ECE/TRANS/WP.29/GRSG/2009/3  
3 February 2009

REGULATION No. 110  
(Specific components for CNG)

Proposal for draft amendments to the Regulation

**"Fig. 2: 20 MPa Filling unit Size 2 (receptacle) for M<sub>2</sub>, M<sub>3</sub>, N<sub>2</sub> and N<sub>3</sub> vehicles**

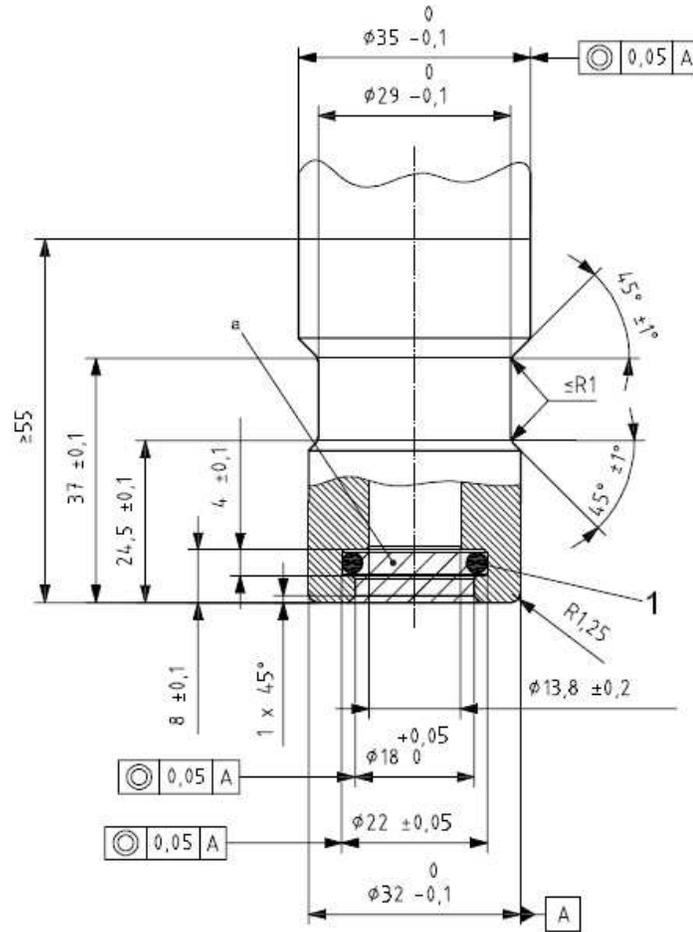
Insert a new paragraph 4.2., to read:

**"4.2. Figure 2 shows the dimensions of the filling unit for vehicles of categories M<sub>2</sub>, M<sub>3</sub>, N<sub>2</sub> and N<sub>3</sub>. 3/"**

Insert a new Figure 2, to read:

1 sealing ID =  $\varnothing 15,47 \pm 0,1$  width =  $\varnothing 3,53 \pm 0,2$

<sup>a</sup> This area shall be kept free of all components

Surface roughness < Ra 3,2  $\mu\text{m}$ .

Sealing surface finish: 0,8  $\mu\text{m}$  to 0,05  $\mu\text{m}$ .

Material hardness: 75 Rockwell B (HRB 75) minimum.
